March 30, 2020

Product Change Notice - Rear drawbar reinforcement plate

Current Design:

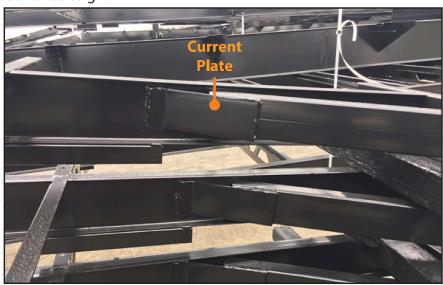
Please be advised, LCI is updating the rear drawbar reinforcement for standard (not undermount) A- frame travel trailers. The new plate allows for crossmembers and tank hangers to be placed closer to the front of the trailer while reducing localized stresses by approximately 40%. Comparative FE Analysis of these designs is available upon request

This change will be implemented on a running basis by model line beginning around April 13. We will be contacting your product engineers to notify when it will affect your specific product.
